2023 - 2024 ARGYLE ELEMENTARY SCHOOL CORRECTION LIST

Occupant Name:	Argyle Elementary	Inspection Date:	12/21/2023
Address:	2625 Spencer Plantation Boulevard	InspectionType:	Annual Fire Safety Inspection
Suite:	Orange Park	Inspected By:	Stephanie Raucci
Location	Code Set	Code	
	FL NFPA 01 2018 Chapter 13 Fire Protection Systems	13.6.3.1.2 - Extinguisher Readiness.	
Admin R-102	FL NFPA 01 2018 Chapter 13 Fire Protection Systems	13.1.8 - All fire protection systems are in operating condition (water on system; no troubles on panel, etc.)	
	Inspector Comments: Battery charger failure at annunciator panel. Have fire protection contractor make required repairs.		
Admin R-113	FL NFPA 01 2018 Chapter 10 General Safety Requirements	10.18.3.1 - Ceiling clearance from storage (non-sprinklered areas).	
	Inspector Comments: Remove storage from areas within 2 feet of ceiling.		
Admin R-117	FL NFPA 01 2018 Chapter 10 General Safety Requirements	10.18.3.1 - Ceiling clearance from storage (non-sprinklered areas).

Occupant Name: Grove Park Elementary
Address: 1643 Miller Street
Suite: Orange Park
Inspection Date: 10/16/2023
Inspection Type: Annual Fire Safety Inspection
Inspected By: Stephanie Rauc

1.1 -
10.18.3.1.

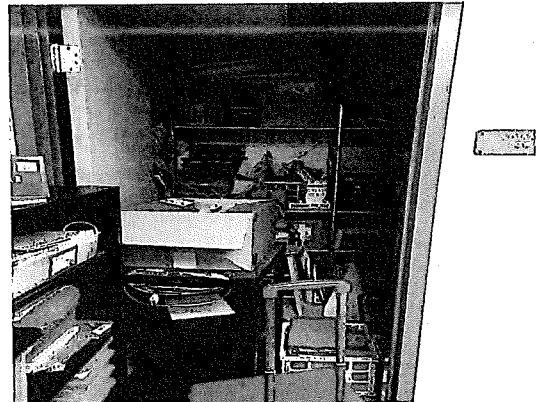
Location	Code Set	Code
	FL NFPA 01 2018 Chapter 10 General Safety Requirements	10.18.3.1 - Ceiling clearance from storage (non-sprinklered areas). (see photo 1.1, 1.2, 1.3, 1.4)
	Inspector Comments: Remove storage from areas within 2 feet of ceiling. Campus-wide: Multiple storage closets have contents too close to the ceiling. R-703A, 708A&B, 603A, and 608A are provided as photo examples.	
Admin R-108	FL NFPA 01 2018 Chapter 10 General Safety Requirements	10.18.3.1 - Ceiling clearance from storage (non-sprinklered areas). (see photo 2.1)
	Inspector Comments: Remove storage from areas within 2 feet of ceiling.	
Cafeteria	FL NFPA 01 2018 Chapter 14 Means of Egress	14.5.2.3 - Locks, special knowledge (see photo 3.1)
	Inspector Comments: Cafeteria serving line door was locked by a non-conforming device. Bracket barricade is not to be used for general use. Locking arrangements shall comply with the Florida Fire Prevention Code.
